Access Compliance Report

Public Rights-of-Way

(Curb Ramps)

Intersection ID: 27397	Main Street: ELM_LN	Cross Street: BALLANTYNE_COMMONS_PY	Location: SW
ADA ID: 0D37EA318C9E	Ramp Type: Perp	Initial Pass/Fail: Fail	Overall Compliance: No
Severity Score: 21.25			
Codes/Mitigation Info/Possible Solution		Field Measurements/Component Compliance

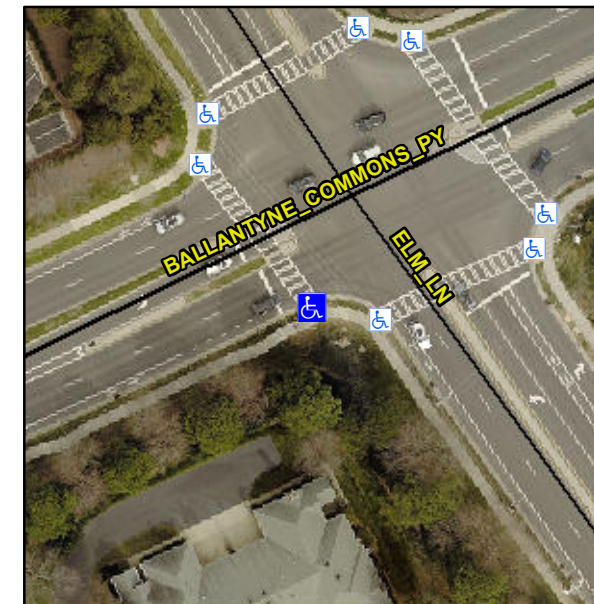
Not Found, R304.5.1, R304.2.2

Compliance	Description	Data	Compliance	Description	Data
N/A	Ramp Length (in)	47.0	No	Ramp Slope (%)	8.8
No	Ramp Width (in)	47.5	Yes	Ramp XSlope (%)	1.9
N/A	Flare Type LT	N/A	N/A	Flare Type RT	N/A
N/A	Flare Slope LT (%)	N/A	N/A	Flare Slope RT (%)	N/A
N/A	Flare Traversable LT?	N/A	N/A	Flare Traversable RT?	N/A
N/A	Landing Length (in)	N/A	N/A	DWS Provided?	N/A
N/A	Landing Width (in)	N/A	N/A	DWS Contrast?	N/A
N/A	Landing Slope (%)	N/A	N/A	DWS Length (in)	N/A
N/A	Landing X Slope (%)	N/A	N/A	DWS Full Width?	N/A
N/A	Landing Curb? (Y/N)	N/A	N/A	DWS Offset (in)	N/A
N/A	Shared Landing?	N/A			
N/A	Gutter Ponding?	N/A	N/A	Gutter Slope (%)	N/A
N/A	Gutter Lip Ht (in)	N/A	N/A	Gutter X Slope (%)	N/A
N/A	Painted X Walk1?	Yes	N/A	Painted X Walk2?	N/A
	X Walk 1 Direction	To NW		X Walk 2 Direction	N/A
N/A	X Walk 1 Width (in)	116.0	N/A	X Walk 2 Width (in)	N/A
	X Walk 1 Slope (%)	2.7		X Walk 2 Slope (%)	N/A
	X Walk 1 X Slope (%)	0.8		X Walk 2 X Slope (%)	N/A

Remove & Replace Entire Ramp.
